The Heath & Hampstead Society

Planning Ref: 2023/5366/P
Address: University College School, Frognal NW3 6XH
Case Officer: Edward Hodgson
Date: 19.05.2024

Please accept this response, further to our previous comments on this planning application.

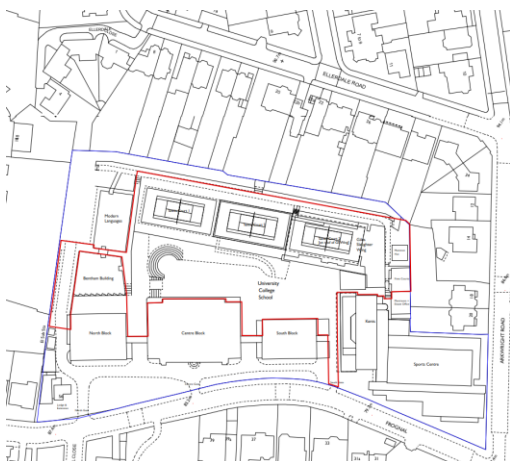
The 'BIA Additional Supporting Information' from A-squared Studio and the 'Final BIA Audit Campbell Reith' have now been uploaded. These indicate that issues of slope stability have been addressed. However, regarding Residents' Consultation Comments from Redington Frognal Neighbourhood Forum (RFNF), and South Hampstead Flood Action Group (SHFAG) - while also ignoring the consultation comments of the Heath & Hampstead Society (H&HS) - the BIA Audit merely states:

'The proposals have included mitigation measures to mitigate any impact to the surface water runoff and drainage regime of the area.'
